PROJECT Turkevi Center
LOCATION Multi Firs
 821 FIRST AVENUE
 NEW YORK, NY
ARCHITECT PERKINS EASTMAN
 115 5th AVENUE, NEW YORK NY
CONTRACTOR TISHMAN CONSTRUCTION
 100 PARK AVENUE, NEW YORK NY

TITLE: Auditorium
ITEM NO.: 11, 11.01, 11.02, 11.03, 11.04, 11.05, 11.07, 11.08, 11.09, 11.10, 11.11
DESC.: PLAN
DESC.: AUDITORIUM SB1-24, VESTIBULE SB1-20 & SB1-17, WAITING ROOM SB1-22
By: PD **Scale:** As Noted **Job No.:** **Dwg. No.:** 11-01
Status: IN SUBMITTAL REVIEW **Date:** 2019-01-21

TITLE: Auditorium
ITEM NO: 11, 11.01, 11.02, 11.03, 11.04, 11.05, 11.07, 11.08, 11.09, 11.10, 11.11
DESC: SECTIONS, DETAILS
DESC: AUDITORIUM S81-24, VESTIBULE S81-20 & S81-17, WAITING ROOM S81-22
By: PD Scale: As Noted Job No. Dwg. No.
Status: IN SUBMITTAL REVIEW Date: 2019-01-21 **11-09**

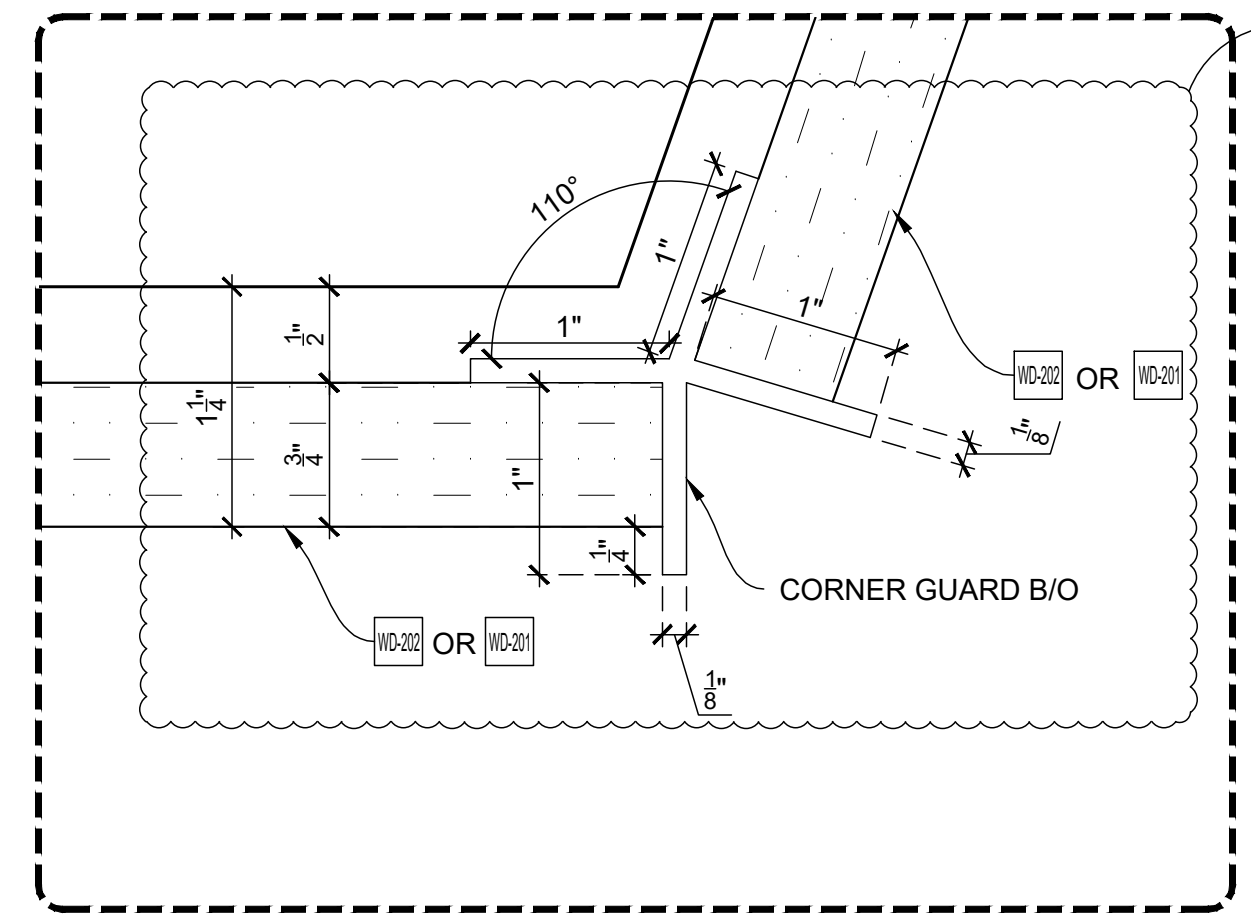
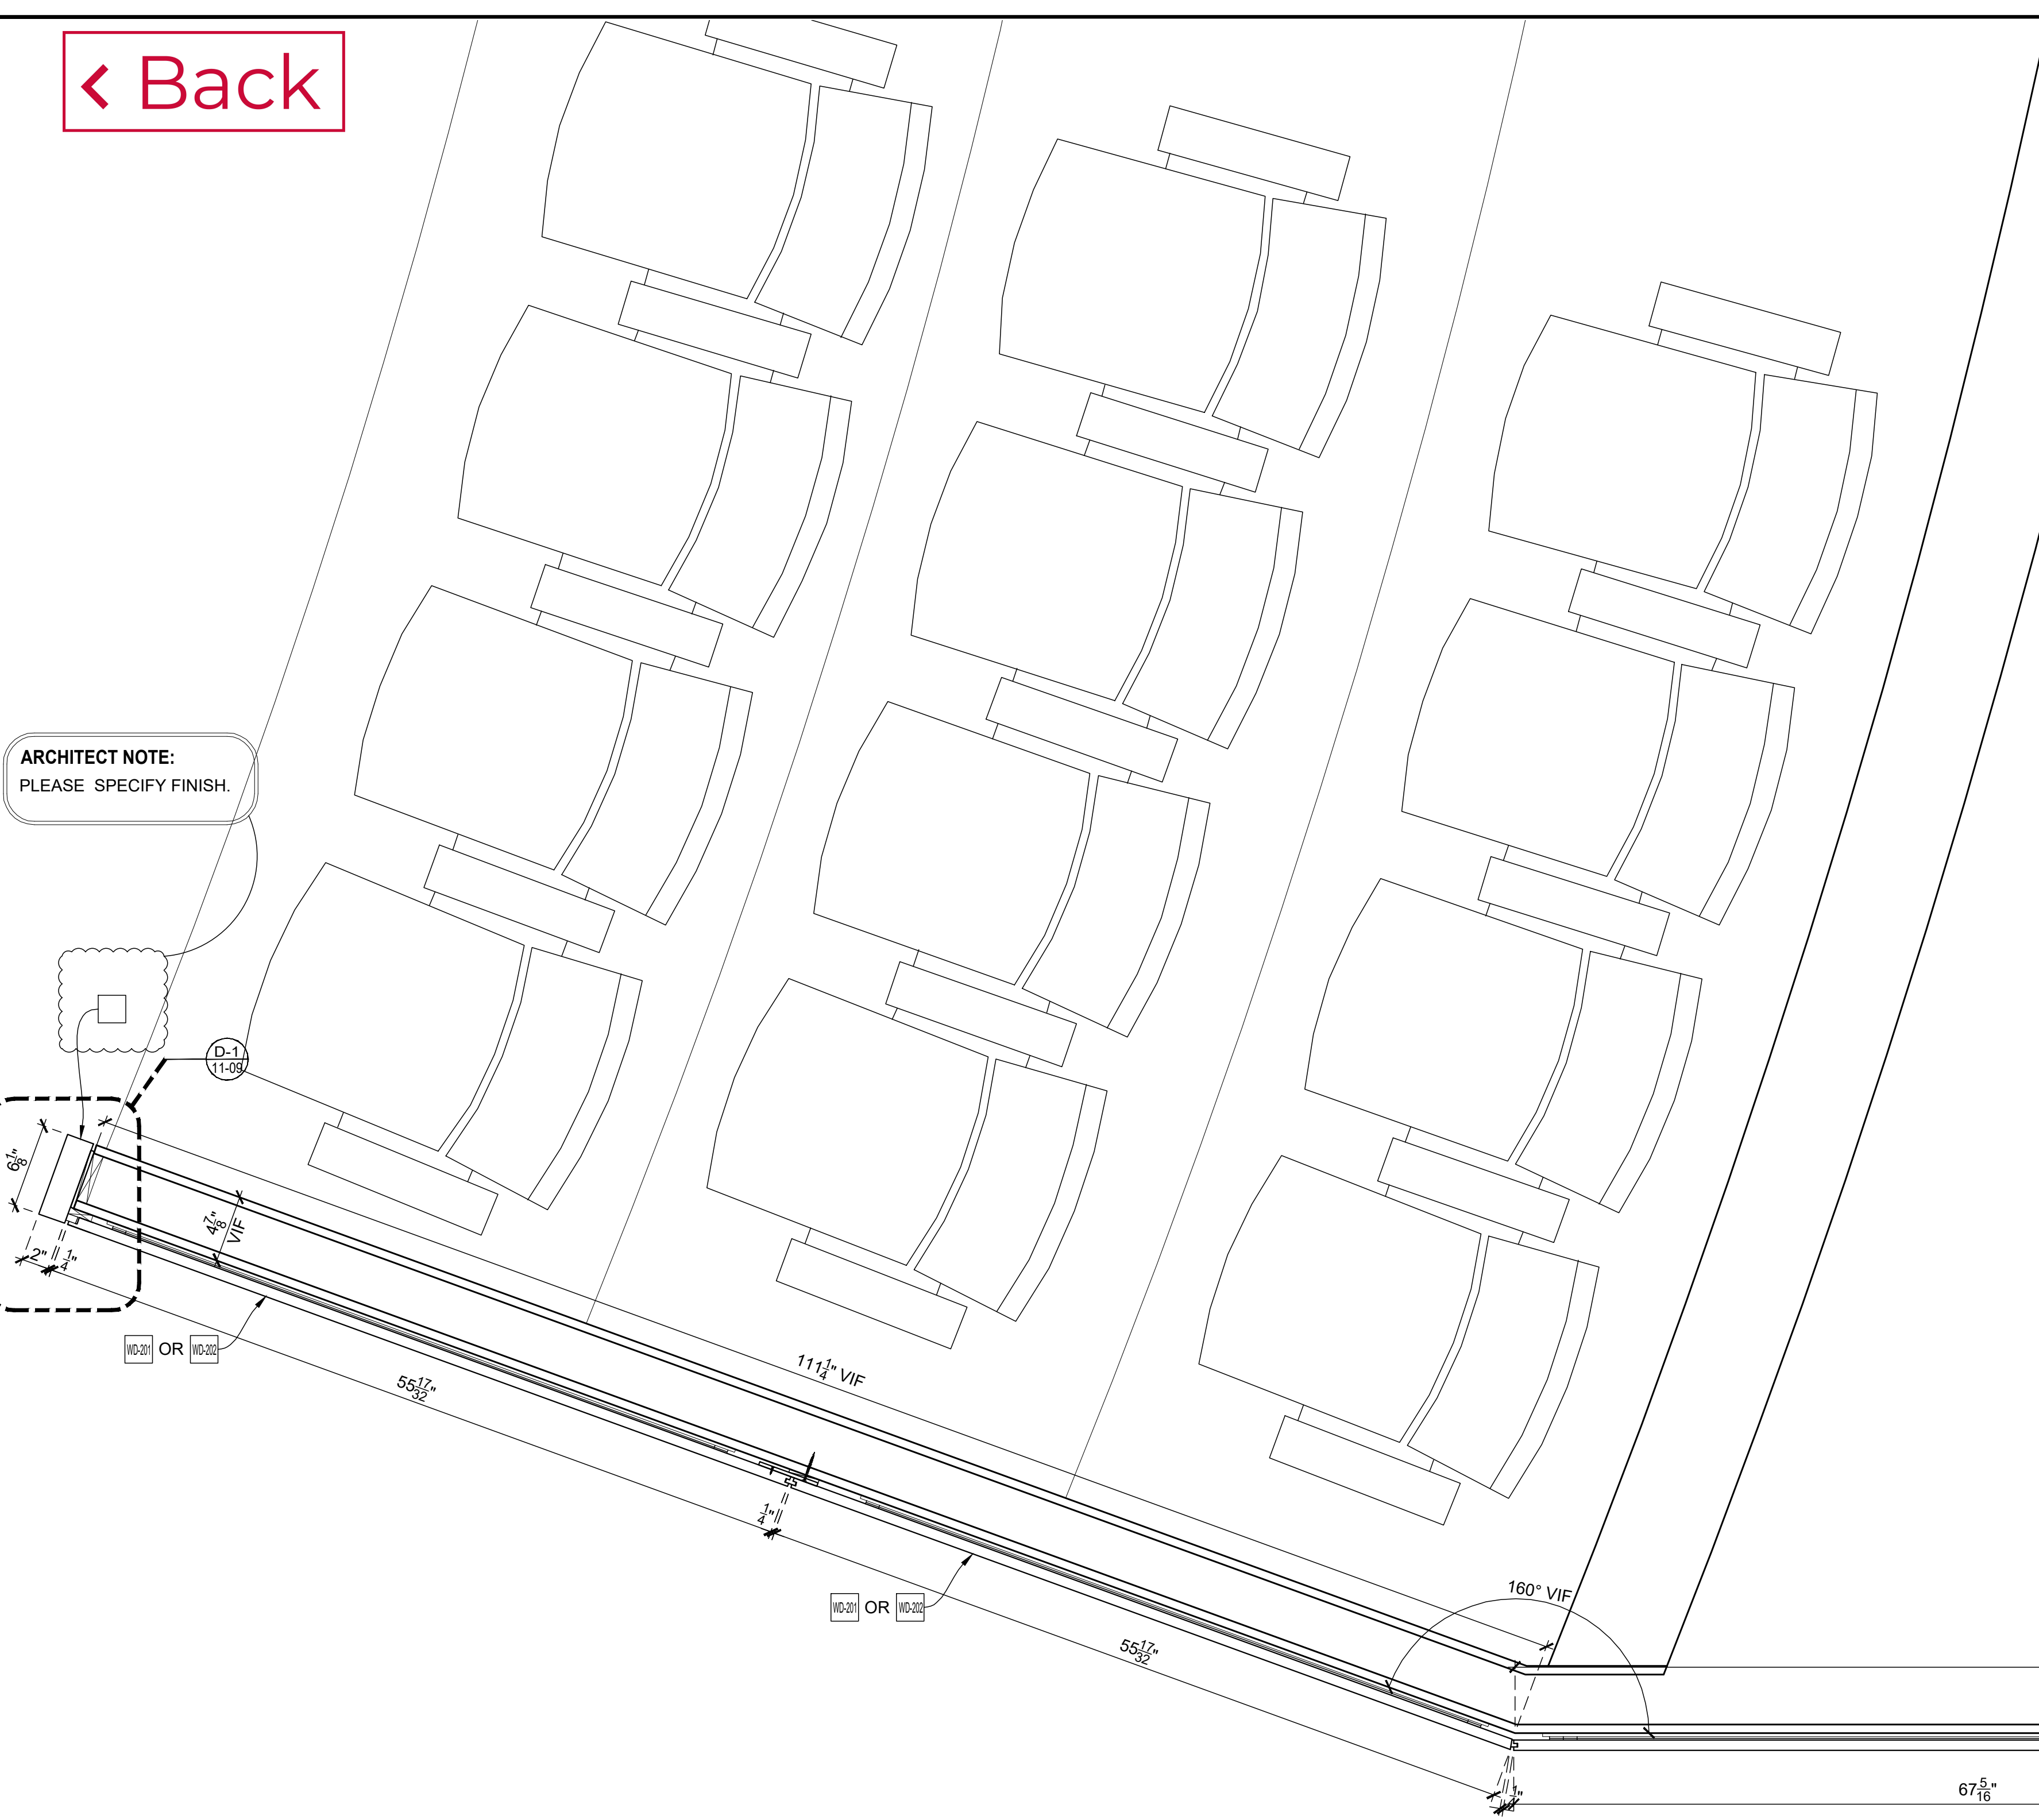
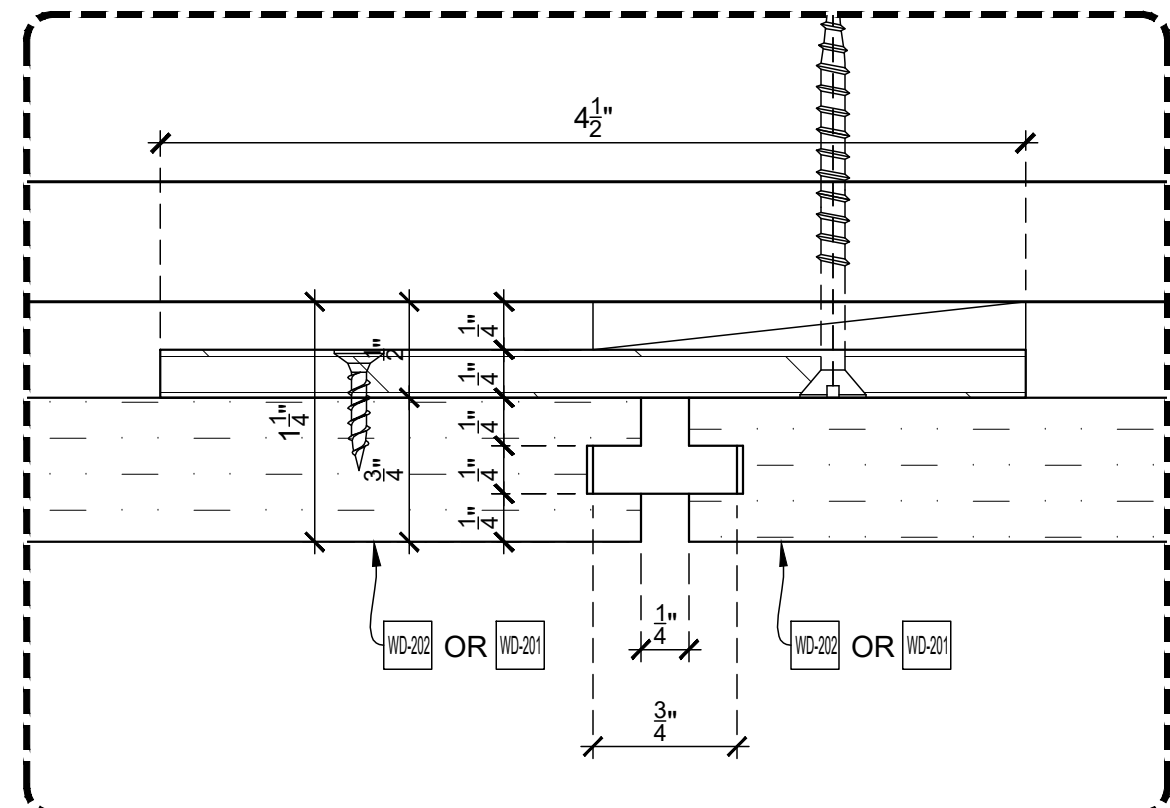
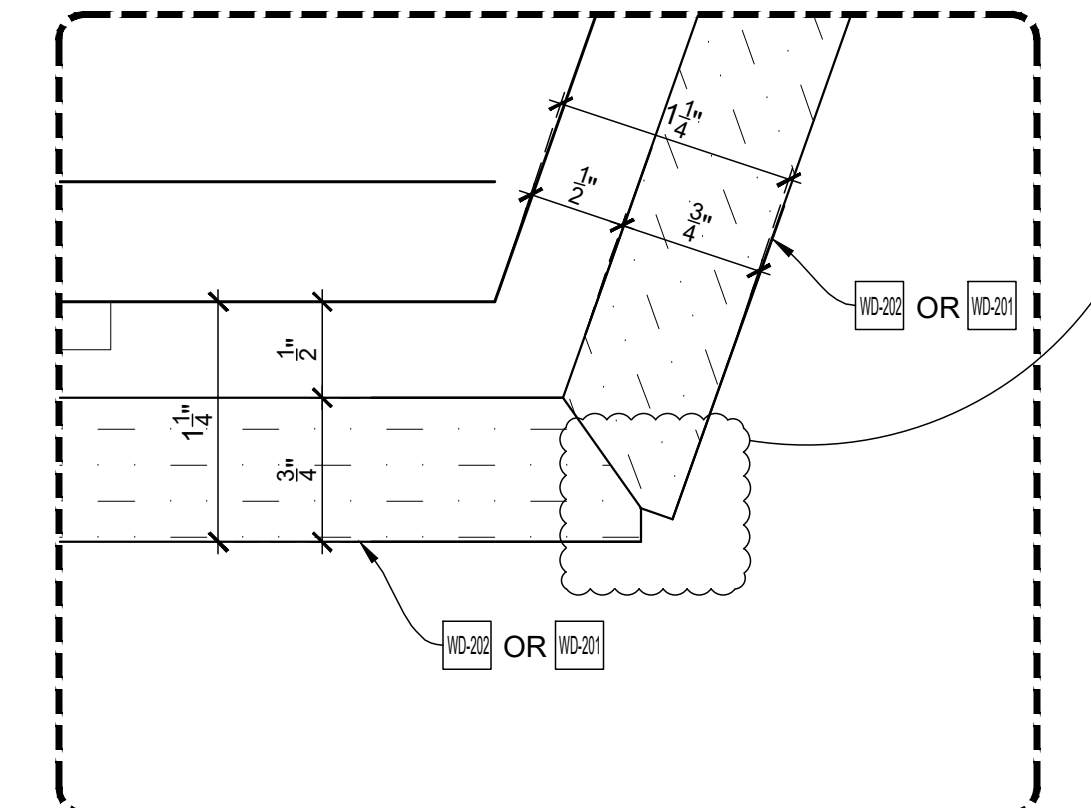
ARCHITECT NOTE:
PLEASE SPECIFY FINISH.

ARCHITECT NOTE:
PLEASE VERIFY SHAPE
OF CORNER GUARD

ARCHITECT NOTE:
PLEASE VERIFY
CONDITION.
